**CEQA ADDENDUM NO. 1**  
**MINOR ROUTE CHANGE PROPOSAL**

**Mitigated Negative Declaration**  
**For**  
**Arena Canal/Howard Lateral and McConnell Lateral Water Conservation Project**

**June 29, 2012**

**Merced Irrigation District**  
**744 W. 20<sup>th</sup> Street**  
**Merced, CA 95340**  
**Contact: Mr. Ryan Lippincott**  
**(209) 722-5761, ext. 2857**

Arena Canal/Howard Lateral Alternative Route  
“Minor Route Change Proposal”

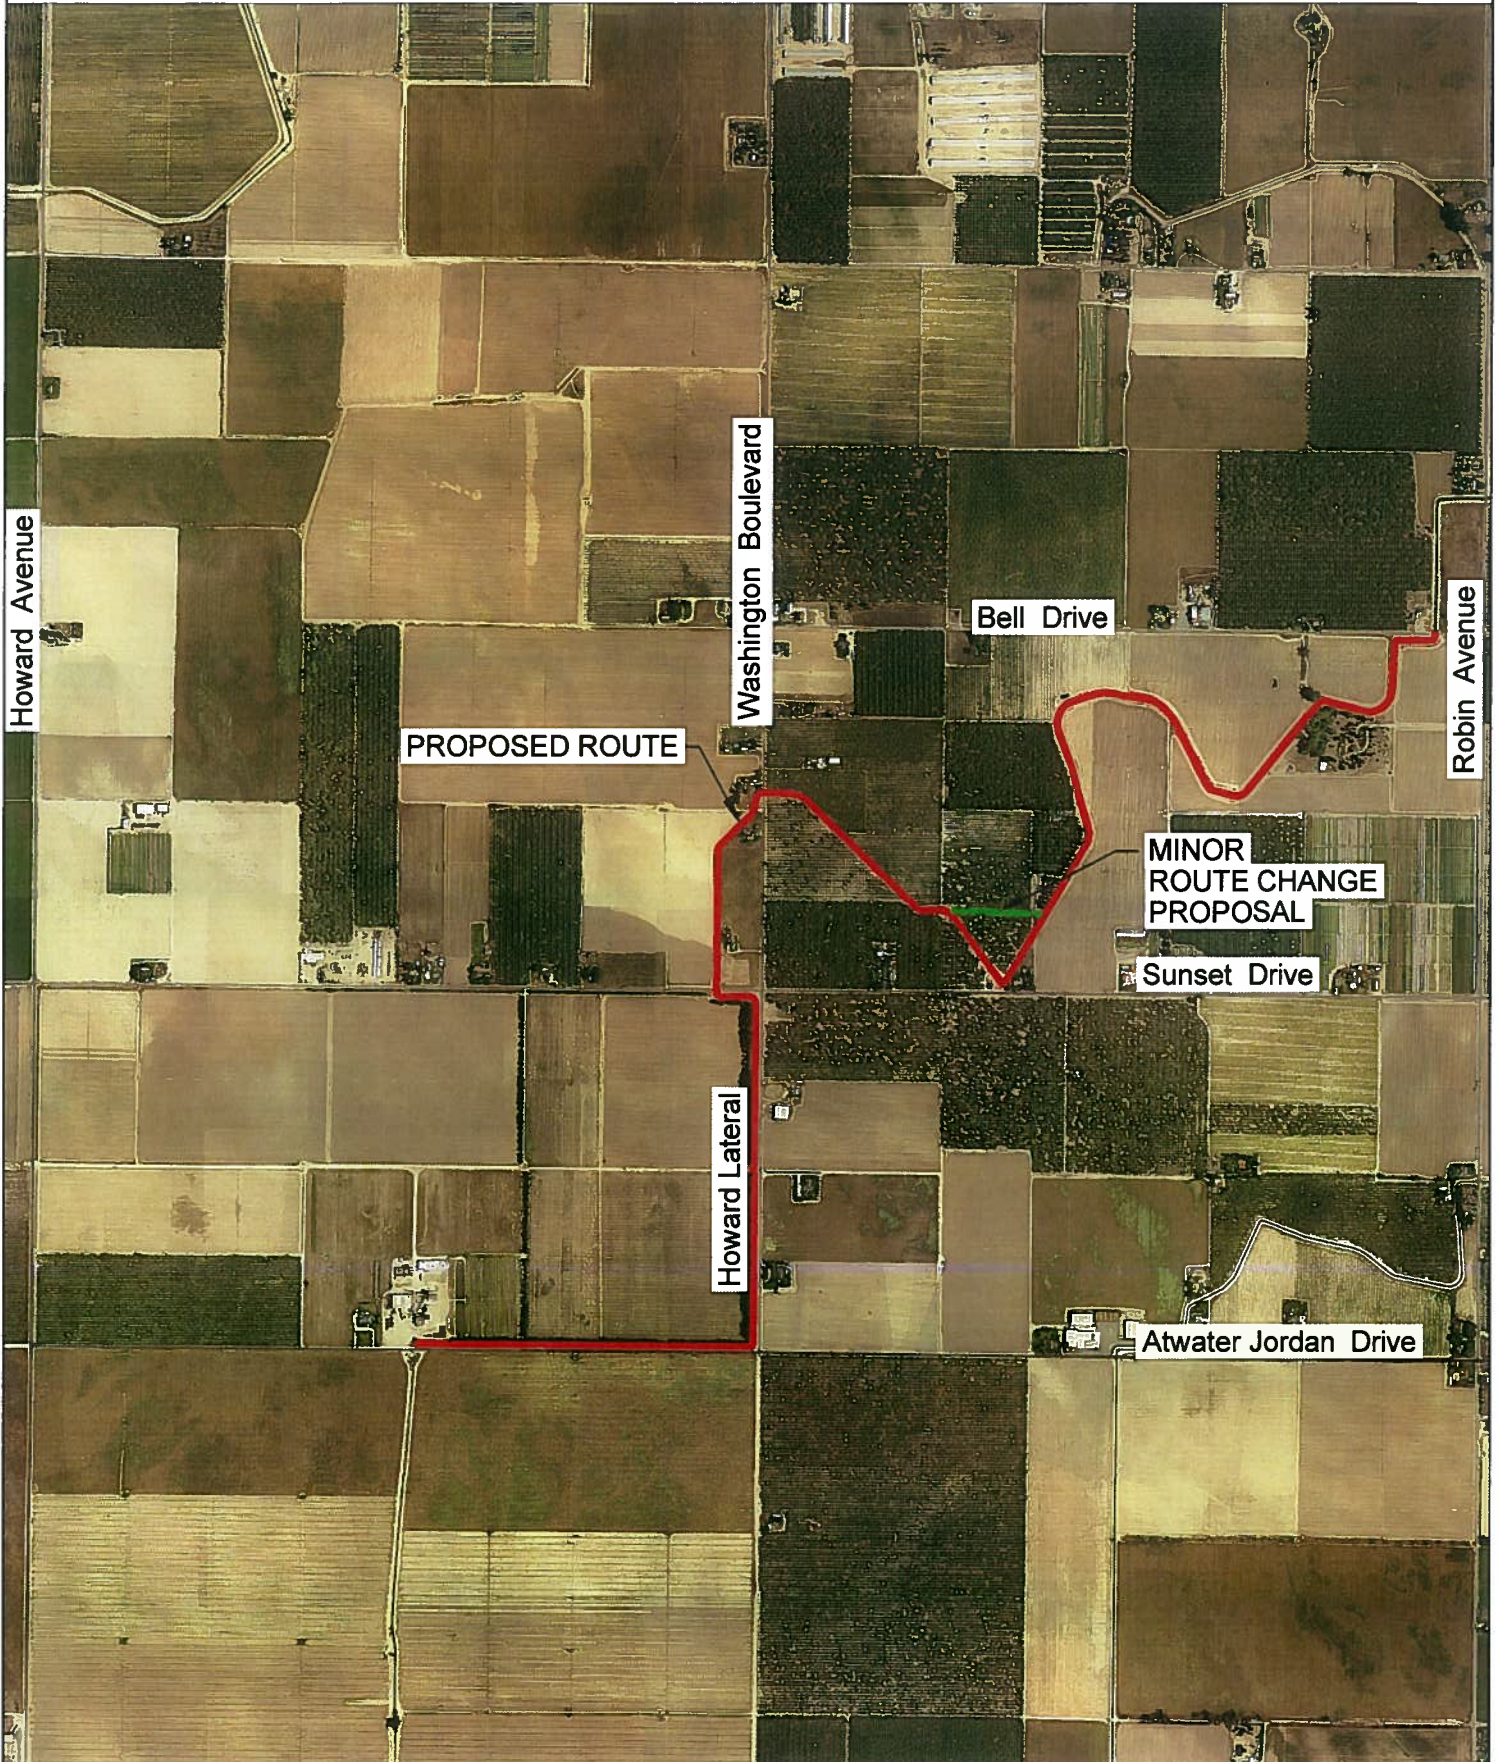
The request is for a minor modification to the project route within the northwest corner of Section 10, T. 7 S., R. 11 E. This route change will be of equal or less distance compared to the current portion of the facility to be improved by the project. Attached Figure 1 shows the change to the route from the approved route that was reviewed and adopted in the MND for the project. The length of new pipeline is approximately 715 feet and the easement area will be approximately 0.60 acres. This route change will result in the replacement of existing irrigation facility to agricultural farmed area in the amount of approximately 0.70 acres. This represents a net gain in land available for farming due to the minor modification to the route of the project improvements.

Attached is a photo of the proposed alignment change to the project, the green line is the change. The District will pipe across the top of the V and then the existing canal in the V area will go away and be farmed, they worked this out recently with the property owner.

I looked at my field notes, aerial photographs, and report. We will not need to do another field survey. This alternate passes through a biologically unremarkable orchard that I viewed from both sides. The current mitigation measures cover tree removal and potential for nesting birds, so shifting the alignment up to go through the orchard is fine.
